MEMORANDUM

TO: City of Milwaukee Plan Commission

FROM: John M. Wirth, counsel for Save MKE's Music Scene LLC

SUBJECT: The Live Nation/Frank Productions Proposed Concert Venue Building Has no Safety Plan and Requires the City to Ignore the Carefully Constructed Zoning Commitments, Requirements and Goals for the Deer District

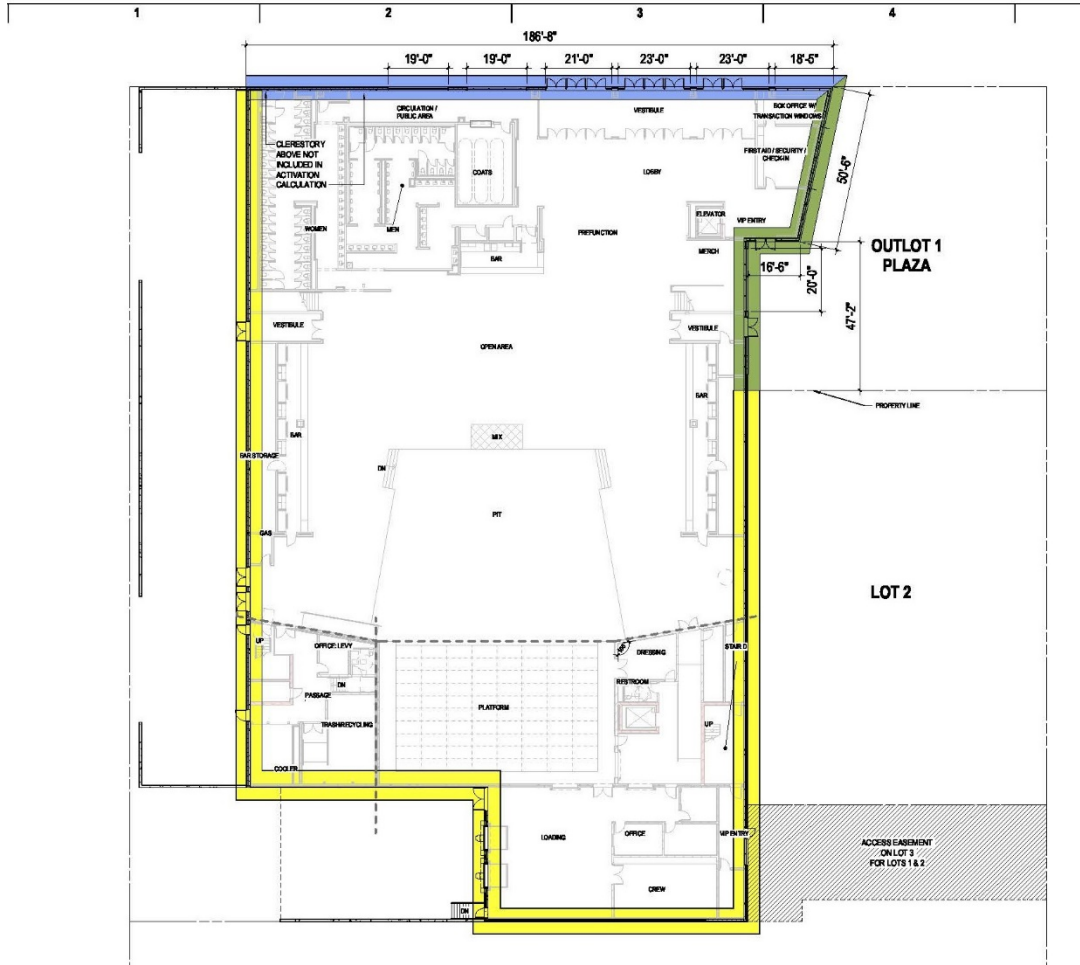
The developer suggests that, someday, a building will be built between the venue and Turner Hall, and then there will be some design feature that will be good for Turner Hall.

Why not now? What commitment can the City rely on that something will ever be built?

Is a **large blank wall with advertising**, or the use of the property to compete with Turner Hall, sympathetic to Turner Hall?

The developer should be required to fulfill its commitment to Turner Hall now. In just nine years, the developer has changed and diminished its plans for this property. You can bet it will again change its tune when (if ever) it proposes something for Lot 2. You can hear them now: “The economics do not allow for the construction of anything interesting on Lot 2 or to cover the 50 feet of blank wall south of Lot 2 in the southeast corner of the venue building.”
